NATIONAL PARK SERVICE
Great Basin National Park
Baker, Nevada 89311-9701

January 9, 2008

National Park Service
Comments on the Ely Energy Center Power Plant
Prevention of Significant Deterioration Permit Application
January 9, 2008

Figure 2. PC Emissions

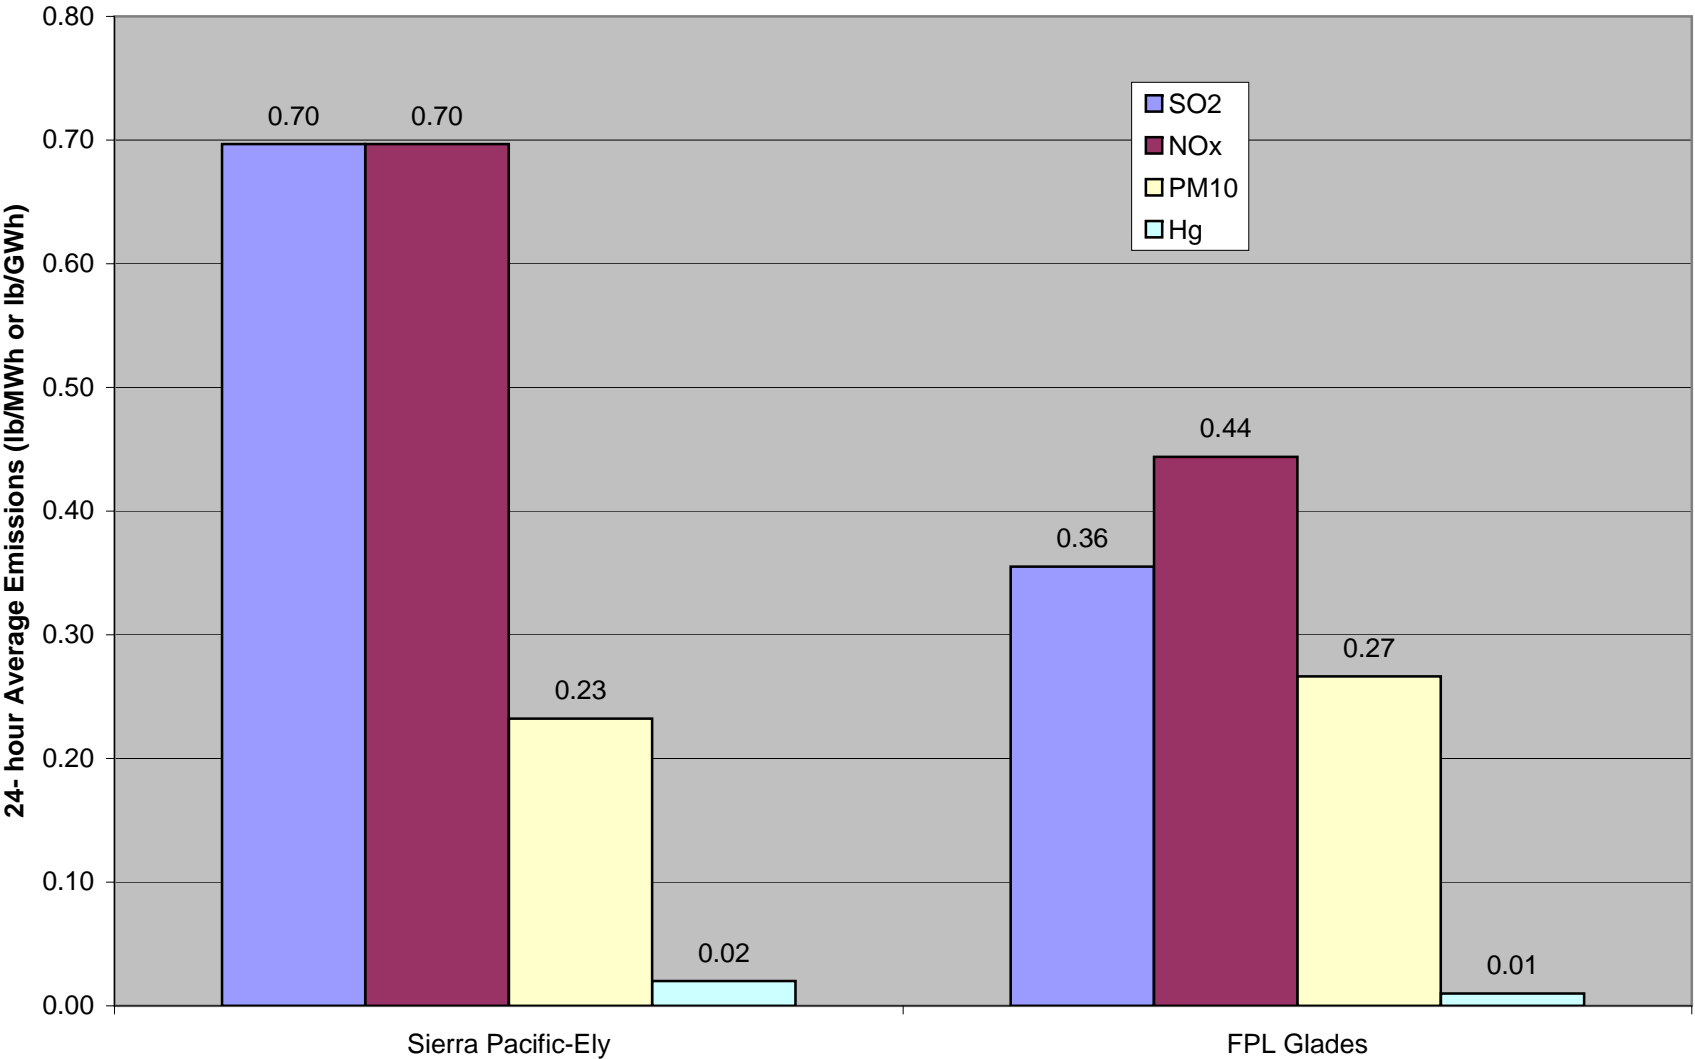
In summary, we believe that further consideration must be given to IGCC "Clean Coal" combustion technology, and believe that EEC could achieve lower SO₂, NO_x, Hg, H₂SO₄ and PM₁₀ emission limits by either choosing an inherently cleaner coal combustion technology or by more effectively using the control technologies chosen for the boiler. Figure 2 illustrates some of the differences between EEC and the FPL Glades project.
